Groundwater Remedy Phase 1 Construction, PG&E Topock Compressor Station, Needles, California

Work Variance Request #3 – Proposed changes within the Construction Headquarters (CHQ) fence line

Revised Drawings for Work Variance Request #3

Drawings from Approved Final Design (November 2015)

CHQ DECONTAMINATION PAD

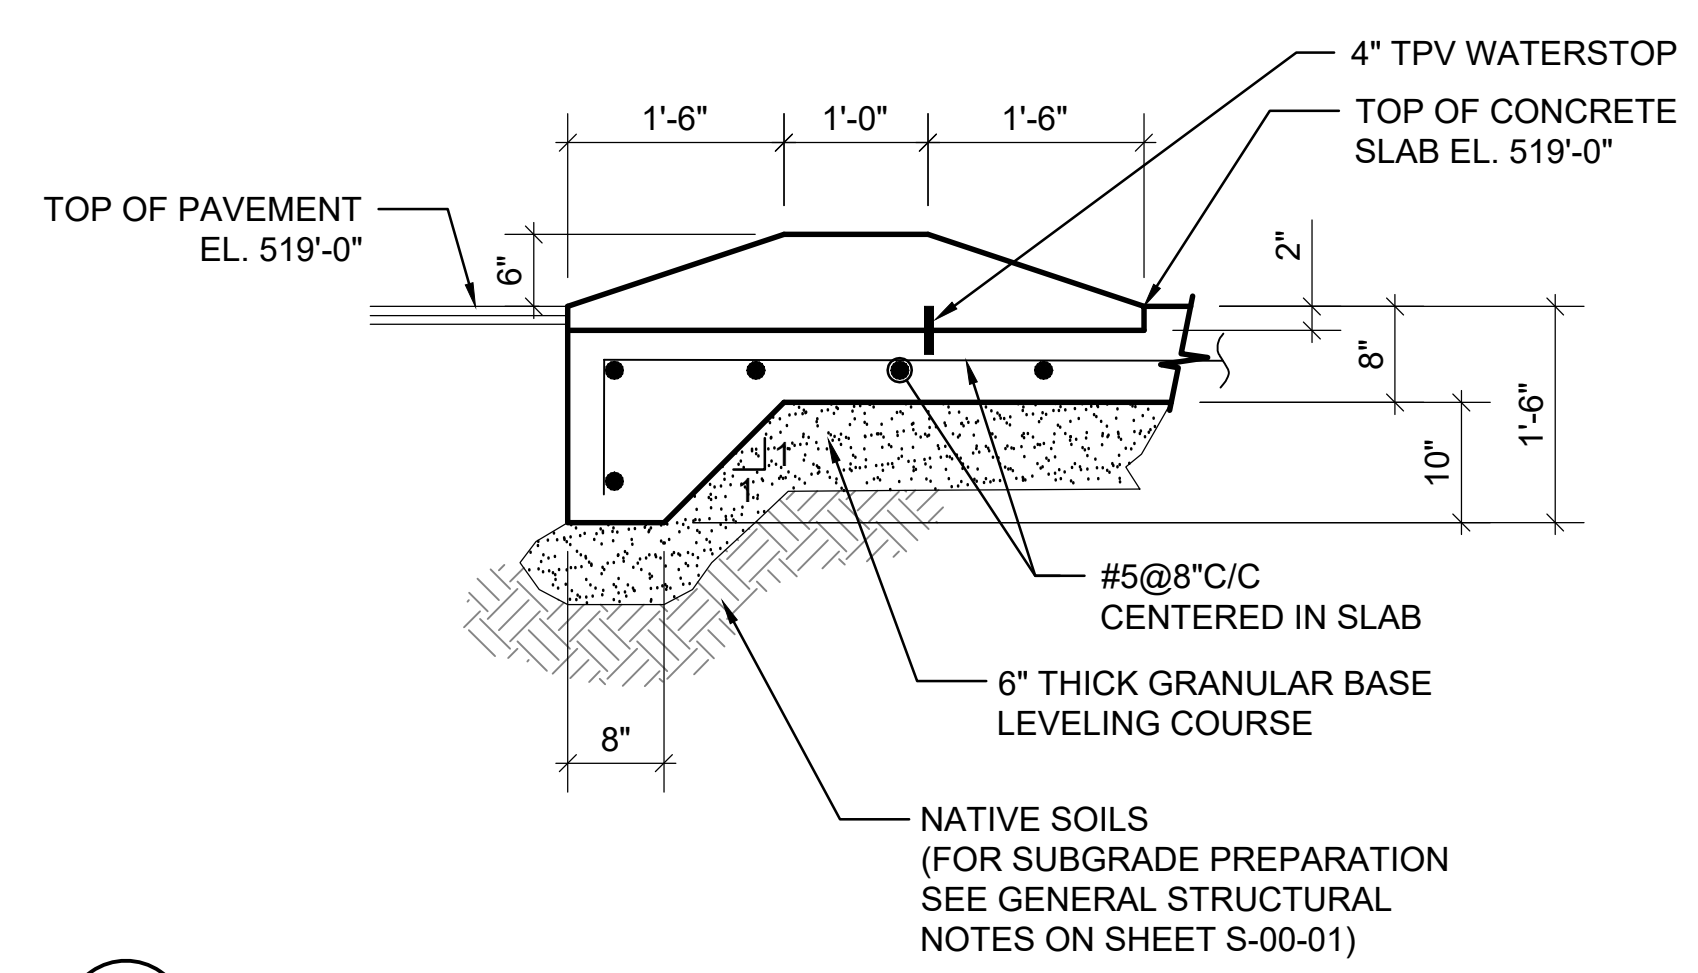
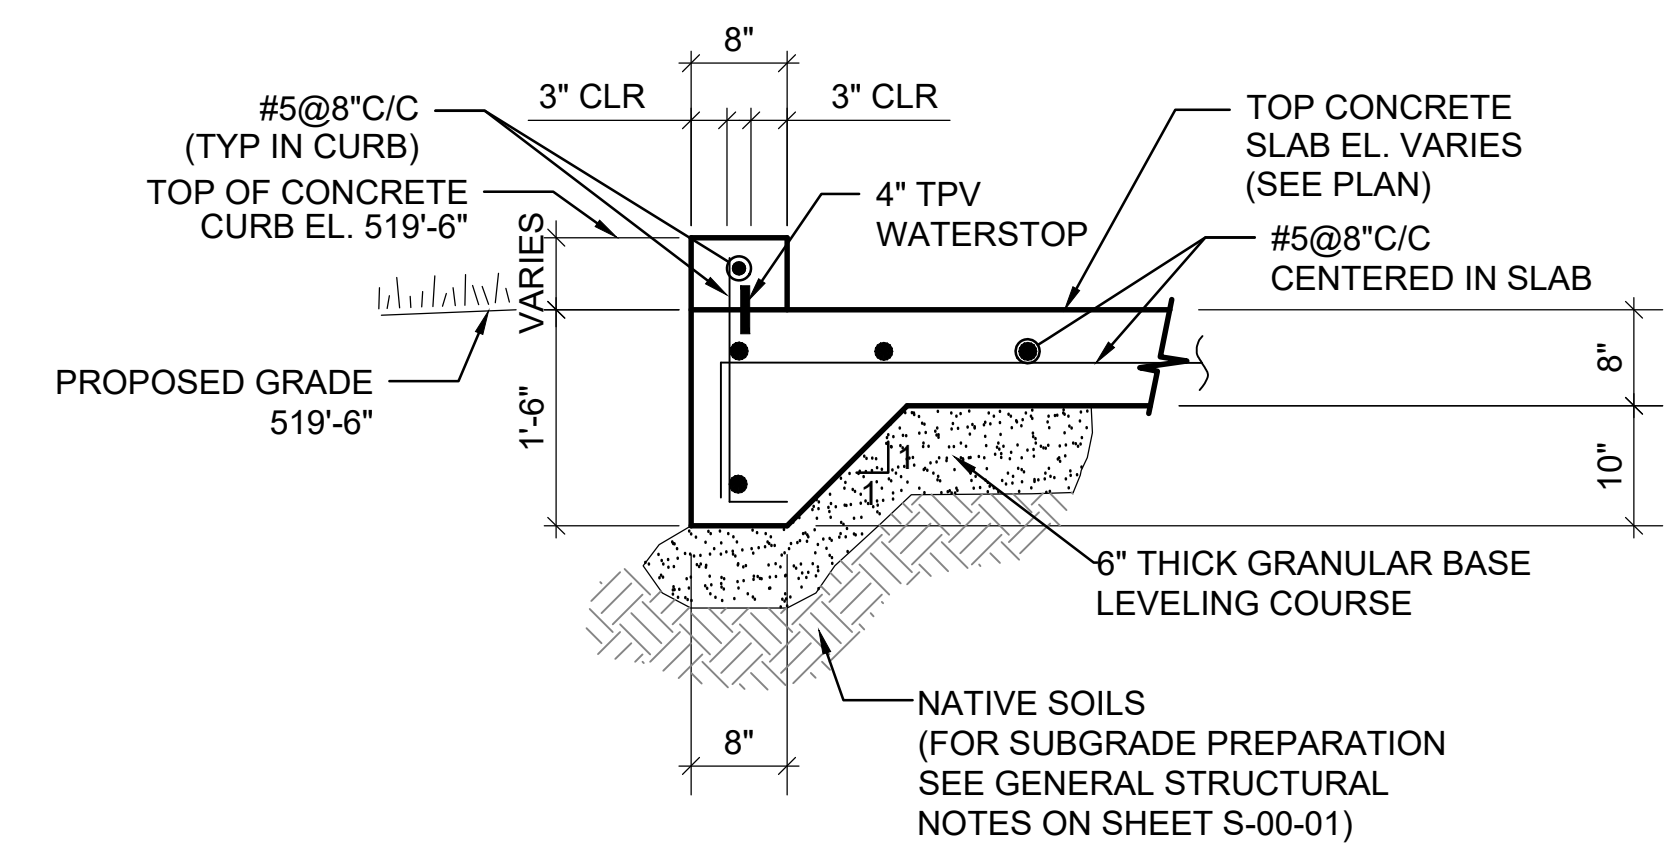
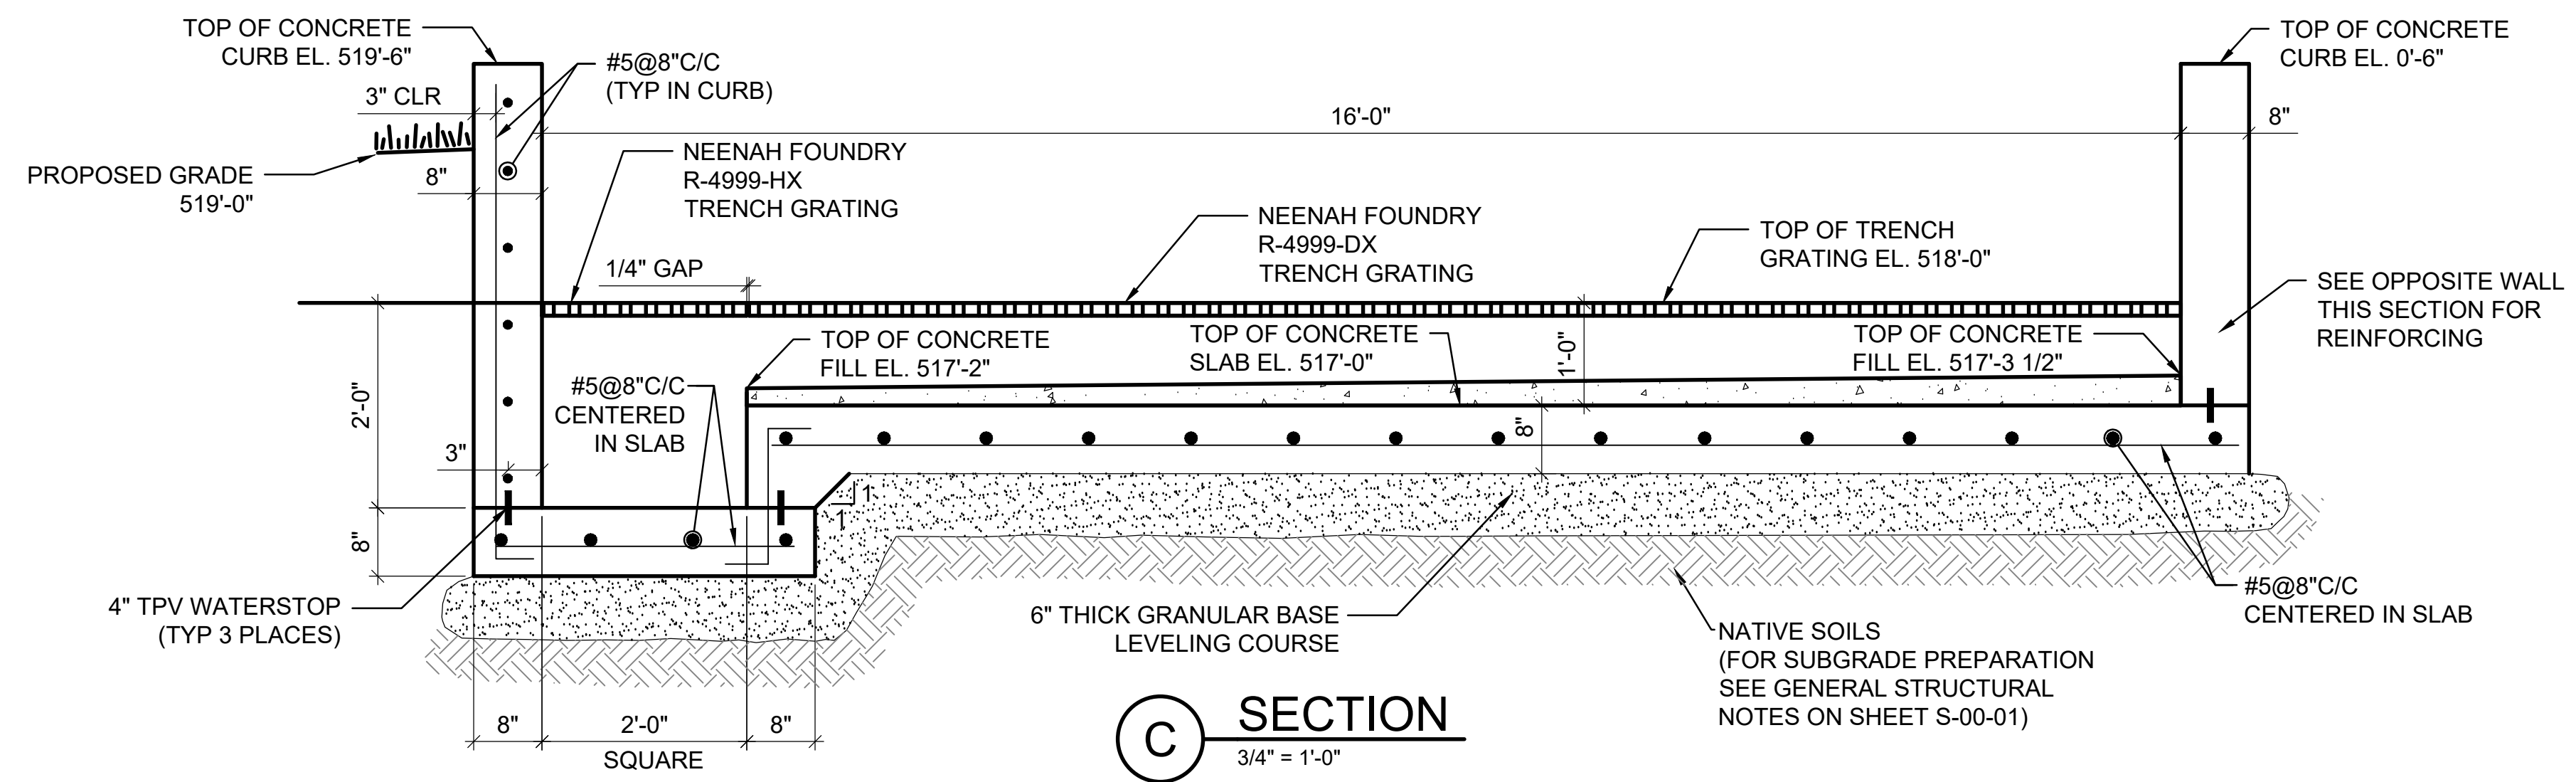
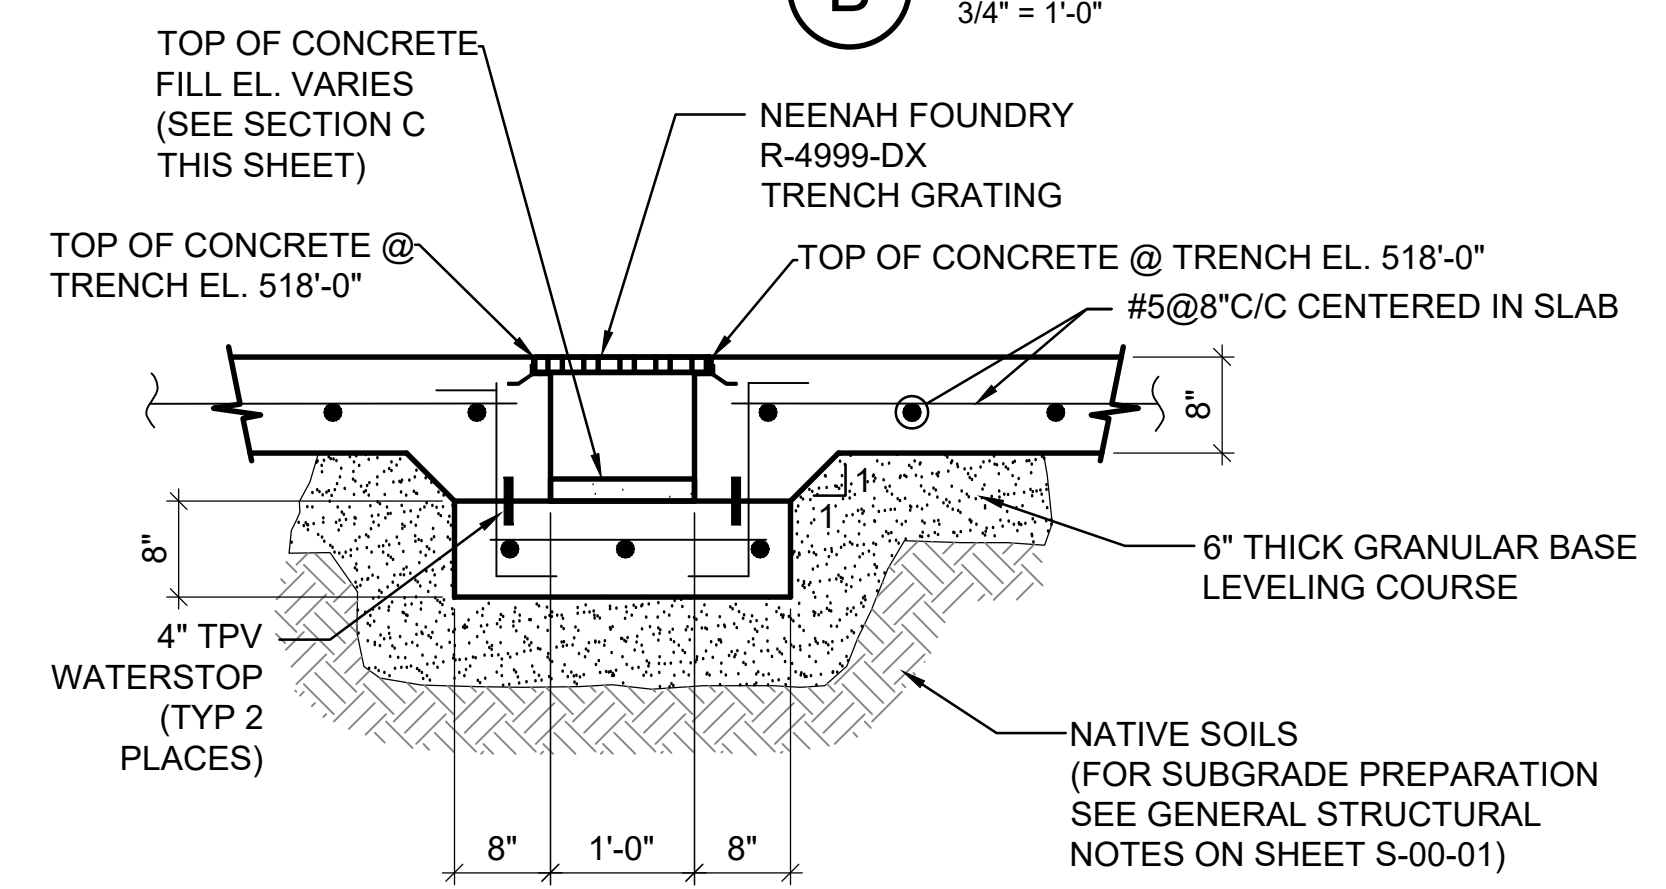
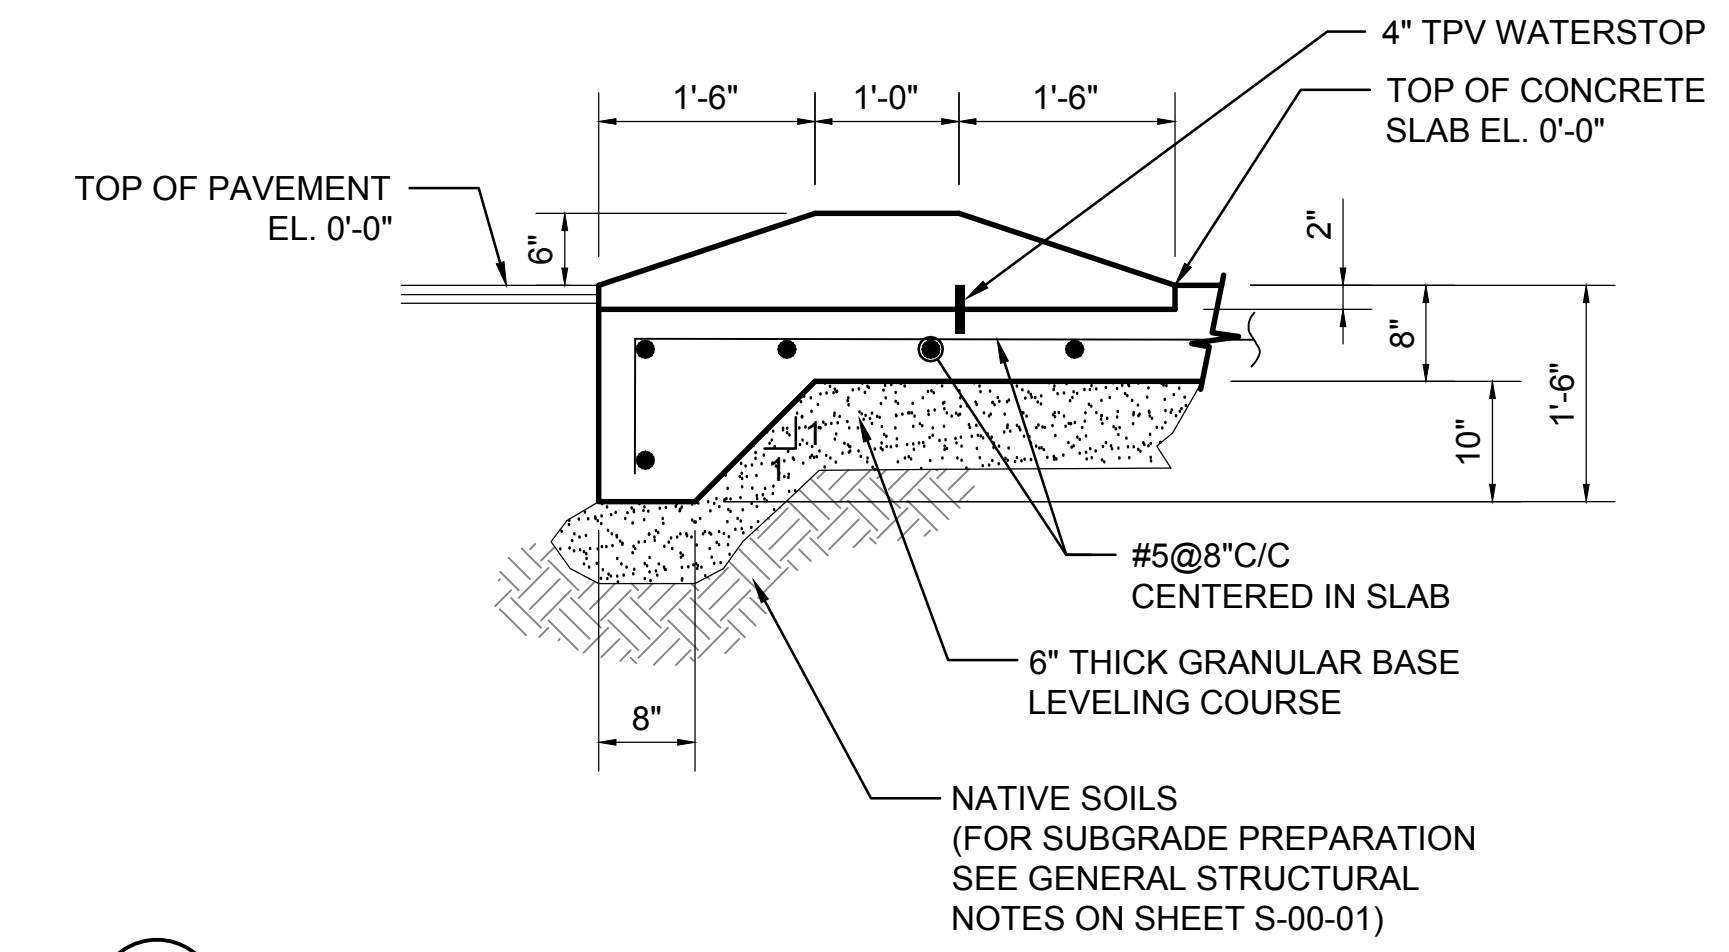
- a) **Relocate the decontamination pad from the western fence to the northern fence (near the western corner).**
Based on recent survey data collected during construction, the difference in ground elevation between northern and southern end of the pad is about 4 feet. Moving the pad to the northern fence would eliminate the difference in ground elevation and reduce the amount of soil disturbance by at least 80 cubic yards.
